CLASS 'B'

- (A) Servicing Instruction/Hunter/74A.
Starboard Instrument Panel : Chafing of Rigid Pipes
- (B) Hunter Mk. 7 and 8 aircraft *Post Mod 779*
- (C) It has been reported that on some aircraft there has been inadequate clearance between the rigid pitot-static pipes from airspeed indicator to machmeter and the body of a Plessey plug to camera recorder on the starboard G.G.S. This has resulted in serious chafing of pitot system pipes with possible failure of system. This is considered due to deformation of pipes during the removal or change of an instrument.

STARBOARD INSTRUMENT PANEL
CHAFING OF RIGID PIPES

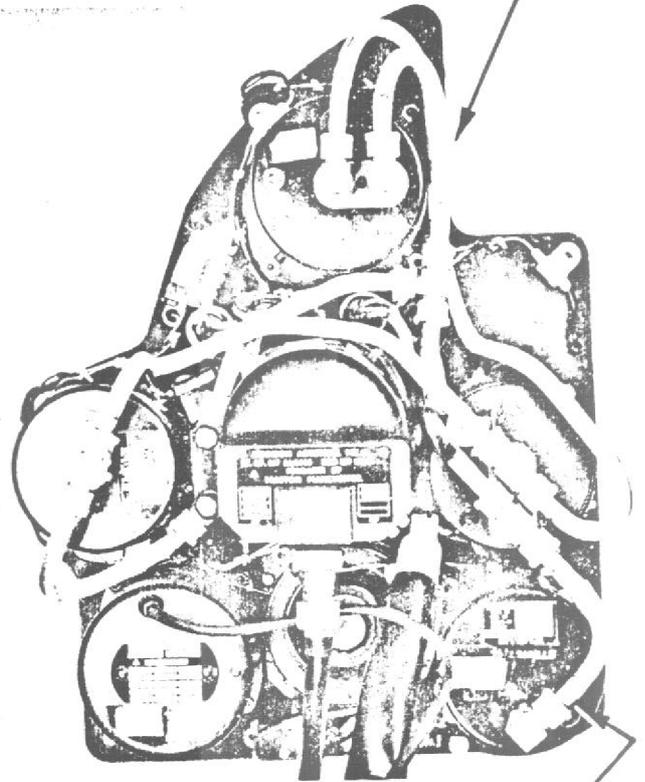
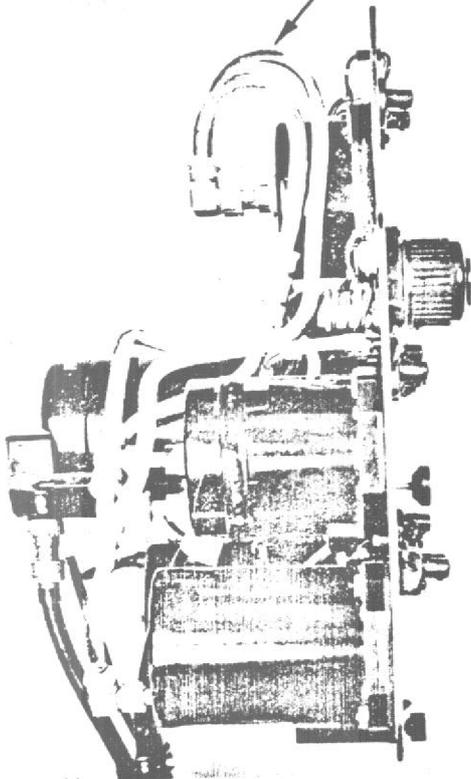
- (a) Remove pilot's starboard instrument panel.
 - (b) Check pitot and static pipes from airspeed indicator for signs of chafing. Renew pipes where necessary, and ensure that the pipe runs conform to the attached photograph.

ENSURE THAT THESE PIPES ARE
POSITIONED AS SHOWN AND DO
NOT PROJECT BEYOND THE BOUNDARY
OF THE PANEL

ALL PIPES TO ENTER STRAIGHT
AND AT RIGHT ANGLES TO CONNECTIONS

NOTE:- PANELS TO BE CHECKED TO THIS
STANDARD AFTER ANY REMOVAL
OR CHANGE OF INSTRUMENTS
